Office Action Summary	Application No. 10/580,928	Applicant(s) SMITH ET AL.	
	Examiner DANIEL CAHN	Art Unit 3634

DETAILED ACTION

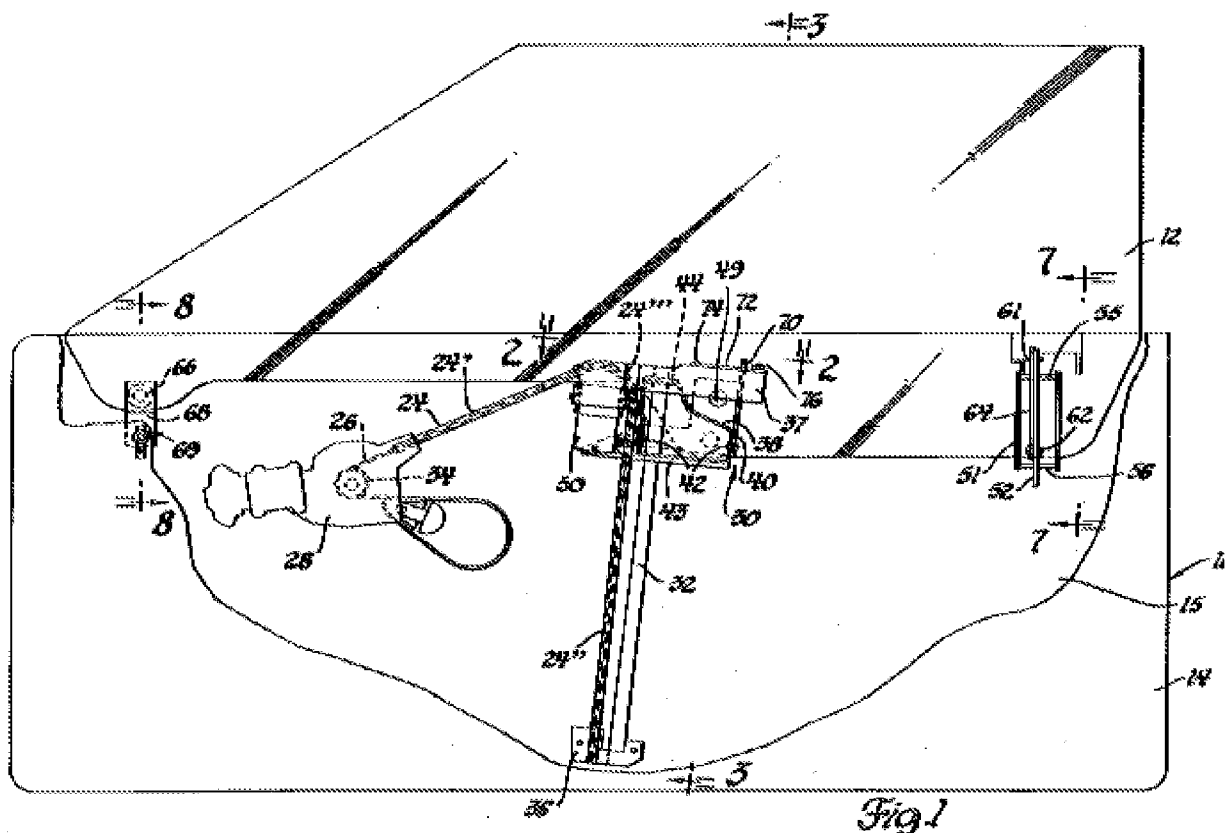
a runner (or yoke 38 and ,43,44; See Fig.'s 3 and 6) including a body portion (38 and 43) and a pair of trunnions (42; Fig. 1, see definition of trunnion below¹), said runner drivingly engaged with said guide rod and moving in said vertical direction along said guide rod between a first position and a second position (as seen between Fig's 3 and 4); and

a window carrier (or yoke 40; see Fig. 3 and 6) including a primary channel (the cavity in which 38 sits; refer to Fig. 6) extending in said vertical direction and a secondary channel (the inherent holes in which the trunnions 42 sit) extending in a lateral direction substantially orthogonal to said vertical direction (as seen in Fig. 5), said body portion of said runner disposed in said primary channel preventing rotation of said runner about said central axis (the body portion at 38, as seen in Fig. 6, is attached to the yoke 40 and if a user tried to rotate it, not only would it be prevented by the block 43 and the drive block 45 (Fig. 5), it would also be prevented because of its size in that if turned it would be stopped by the impediment of track 24, again see Fig. 5) and said trunnions disposed in said secondary channel coupling said runner and carrier for movement of said carrier with said runner in said

vertical direction, said trunnions defining a lateral axis substantially orthogonal to said central axis (see Fig. 5);

wherein said carrier rotates about said lateral axis and translates in a horizontal direction (as seen between Figures 3 and 4; examiner notes that as the carrier 40 rotates, it also inherently translates or moves/relocates in a direction orthogonal to the both the linear and vertical axes previously mentioned) **substantially orthogonal to said vertical and lateral directions in response to moving said runner between said first and second positions, whereby rotational and translational movement of said carrier permits nonparallel movement of said carrier with respect to said central axis as said runner moves between said first and second positions** (this can be seen in Figures 3 and 4).

Images from Podolan

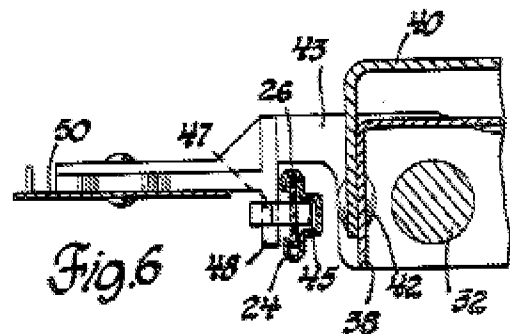
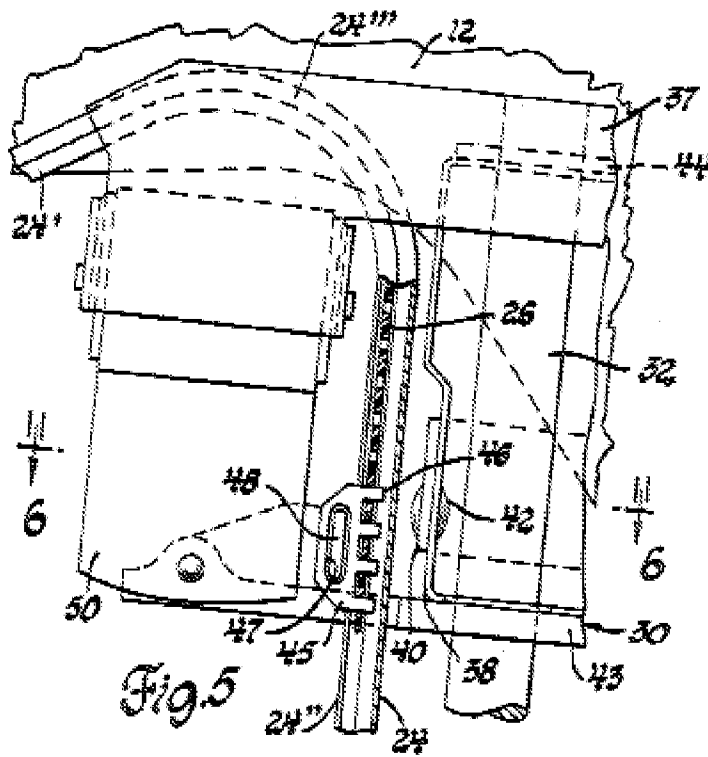
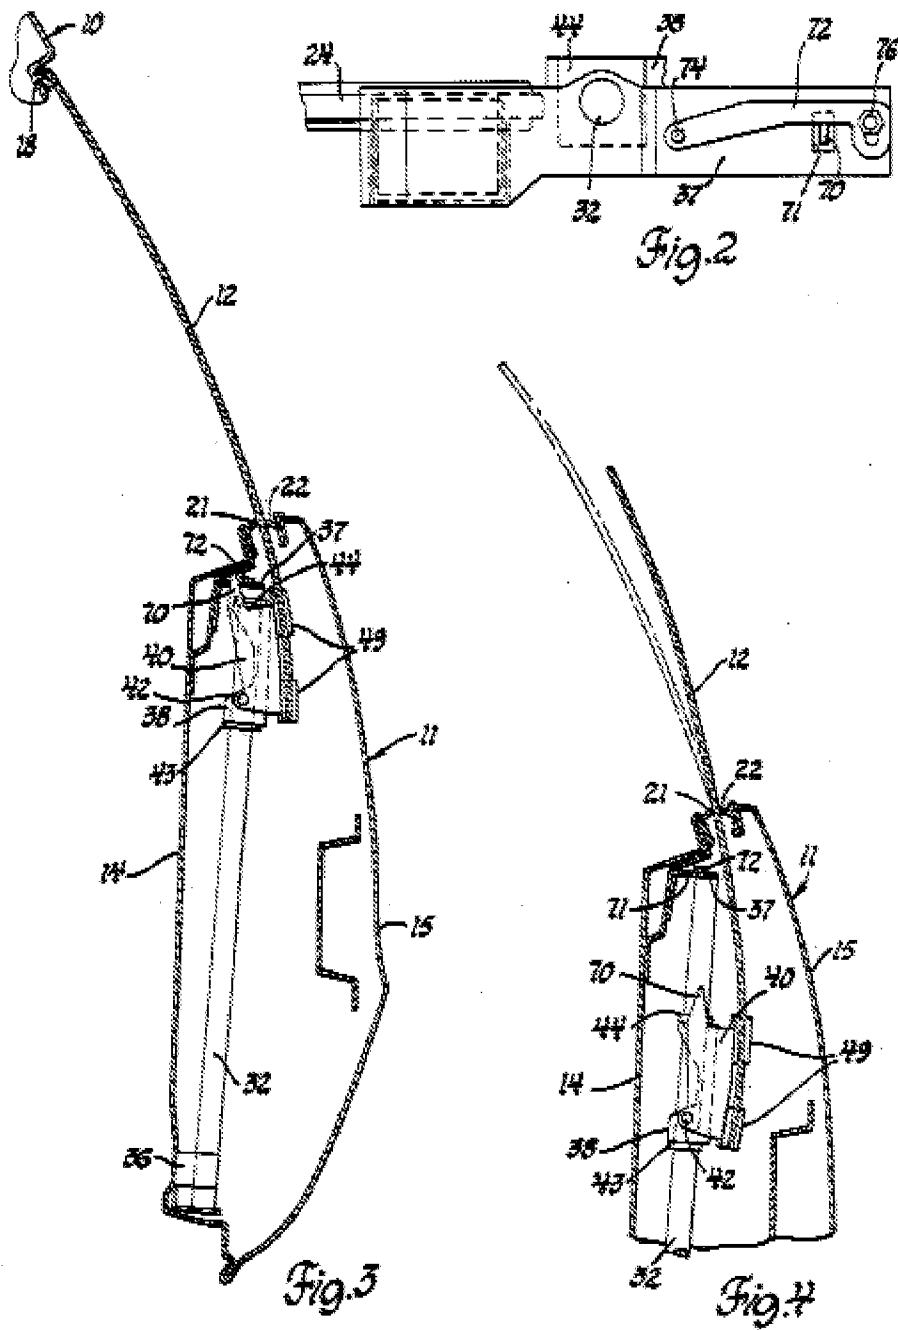
Regarding claim 1, Podolon teaches an **automotive window regulator system comprising:**

a guide rod (32; Fig. 1 and 2) defining a central axis extending in a vertical direction;

Regarding claim 19, **Said trunnions include an elliptical surface** (as seen in fig. 6), **said elliptical surface (inherently) bearing on opposing surfaces of said secondary channel** (as seen in Fig. 6 as well).

Images from Swift

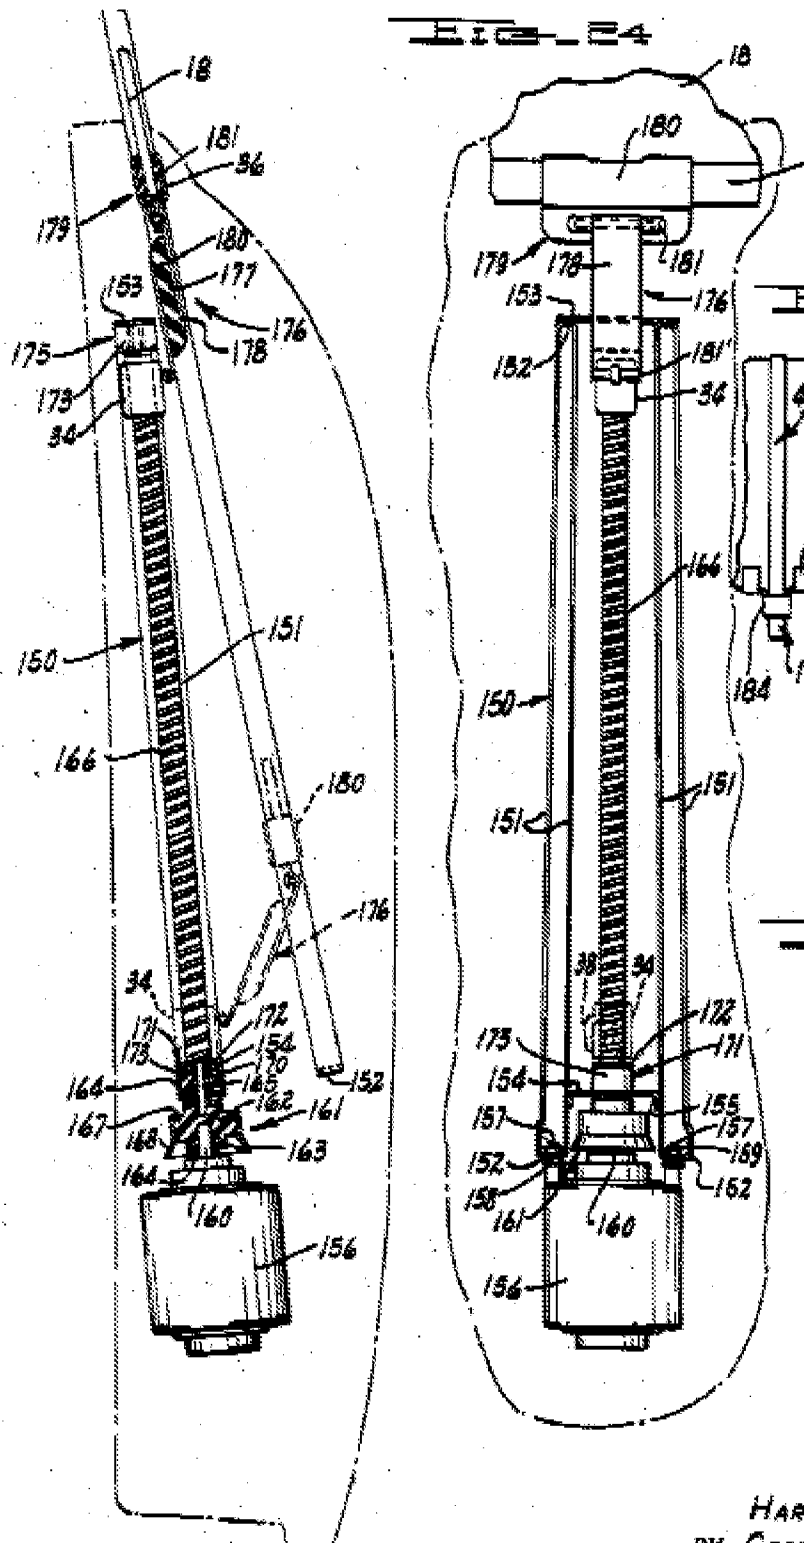
Regarding claim 7, the modified system of Podolon further teaches **said guide rod as a straight threaded screw** (see Swift Figures 23/24) **and said runner as including a threaded bore threadingly received** (as discussed in excerpt 2 below) **onto said screw.**

Regarding claim 8, **the system further includes a motor (156; Fig. 23) which rotationally drives said screw about said central axis to move said runner between said first and second positions** (see Figure 23).

Kondo Excerpt

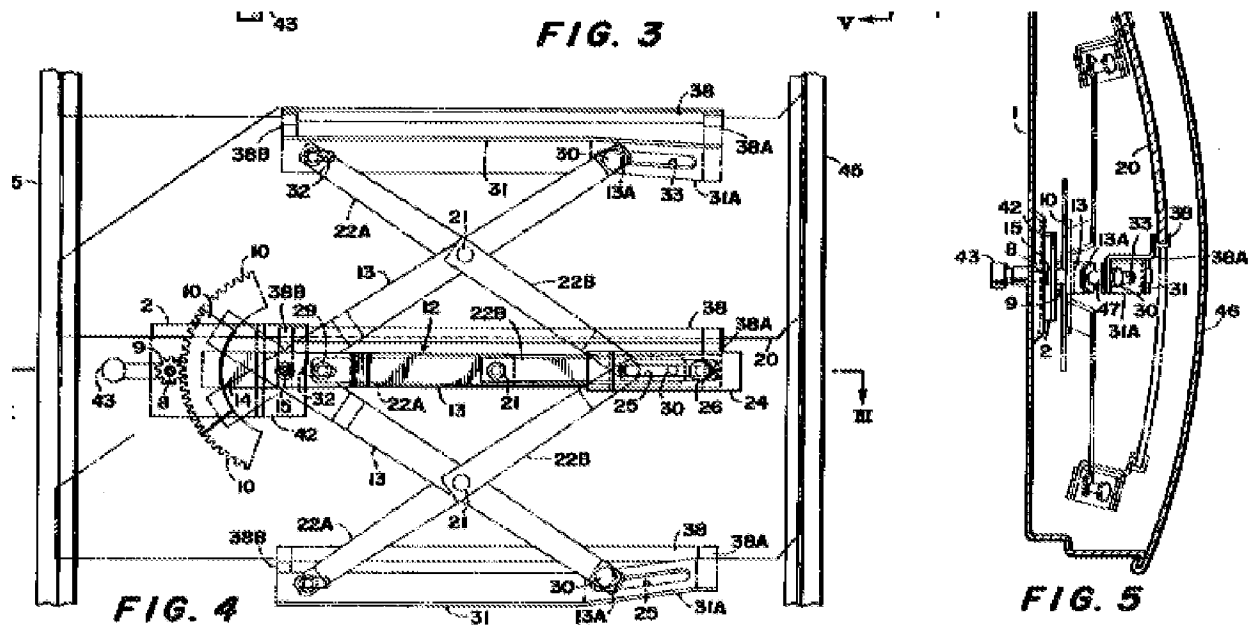
Regarding claim 2, all of the elements of the instant invention are discussed in detail above except providing an arcuate window mounted to the carrier where said window has a radius of curvature and said system further includes a first and second glass run channel each of which have substantially the same radius of curvature of the window. Further which first and second edges of the window are received by the glass

run channels and which they define the path of travel of the window as the runner moves between a first and second position. Attention is therefor drawn toward Kondo which teaches a similar window regulator system having the previously discussed limitations as seen in Fig. 5 and further discussed in the final few lines of the second paragraph of the Kondo excerpt inserted below. It would have been obvious to one of ordinary skill in the art at the time of the invention to have provided the modified system of Podolon with the curved window and curved glass run channels as taught in Kondo in order to provide the curved structure demanded by the shape of the vehicle as while reducing friction cause to the glass run channels. This is just one of a few reasons one skilled in the art would do provide these elements.
